Rezoning Transportation Analysis
Petition Number: Insert Zoning Petition #2021-036
General Location Identifier: Tax ID 06306125

Revision Log:	Date	Description
	04-29-21	First Review (EL)

Rezoning Transportation Analysis

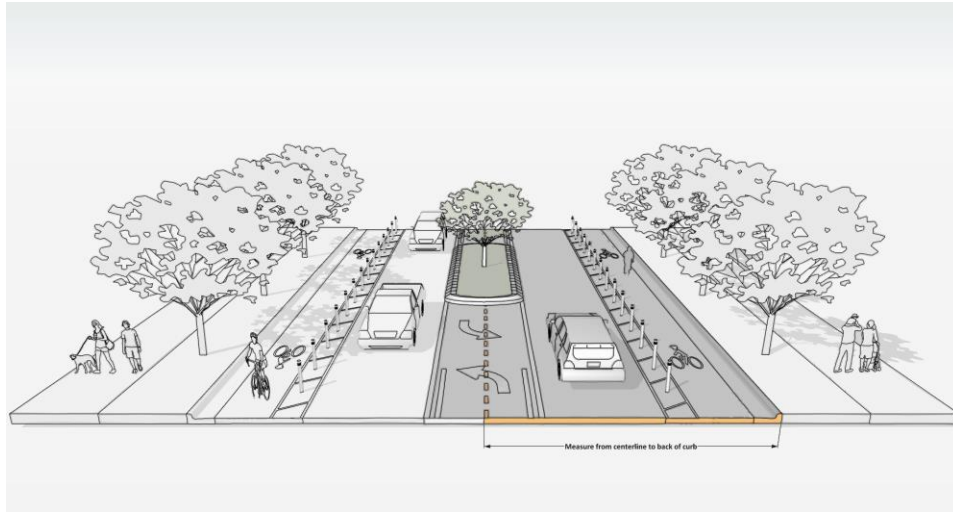
1. **Curbline:** The proposed zoning district has a setback measured from back of the existing or proposed future curbline.
 - a. **South Hoskins Road:** The future location of curb and gutter is 27.5-feet from road centerline. While the existing curb and gutter may remain in place, show the future curbline location for reference.

- b. **Gossett Avenue:** The future location of curb and gutter is in its existing location.

Label and dimension the curb and gutter from the centerline for each road on the site plan.

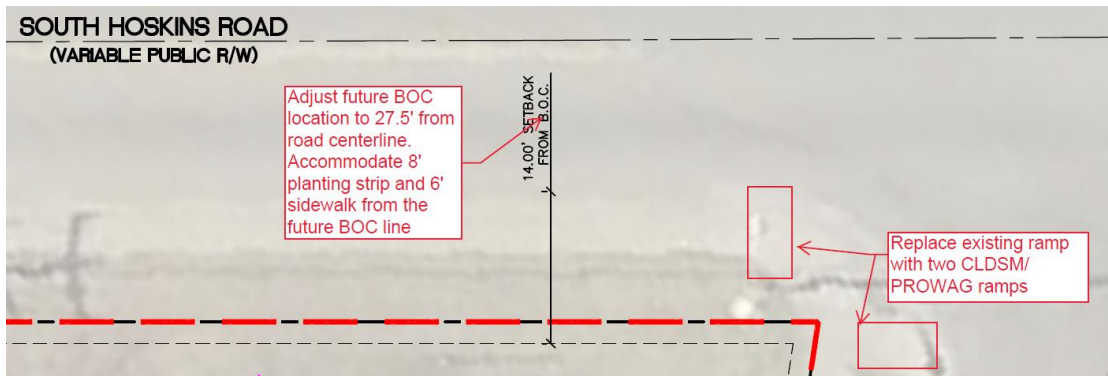
3. Revise the site plan and conditional note(s) to commit to construct an 8-foot planting strip and 6-foot sidewalk on South Hoskins Road, labeled and dimensioned from the road centerline and future curb line location, in support of the Charlotte WALKS Council-adopted policy. Replace the existing accessible ramp at the intersection with two standard CLDSM PROWAG directional ramps.

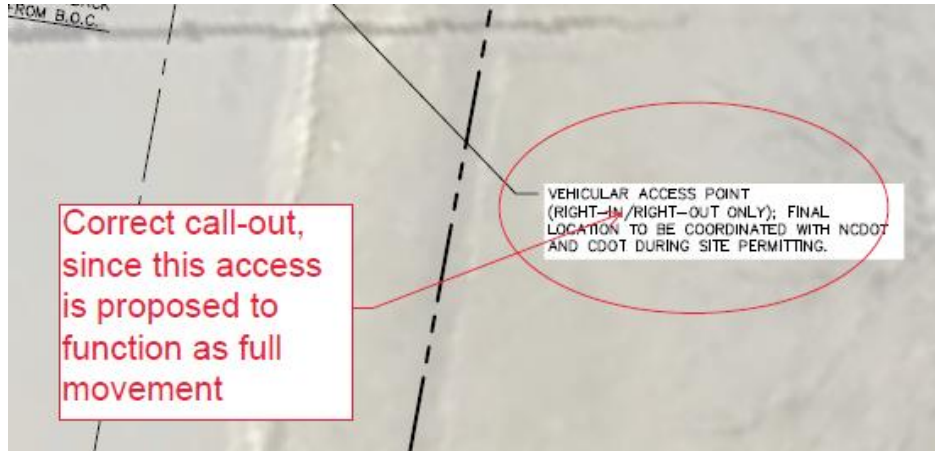
4. Site plan and conditional note(s) revisions are needed to dedicate and dimension 43.5-feet of right-of-way from the South Hoskins Road centerline, to accommodate the future cross section that accommodates a buffered bike lane facility per the Charlotte BIKES Council-adopted policy.
5. Site plan and conditional note(s) revisions are needed to correct the driveway call-out below.
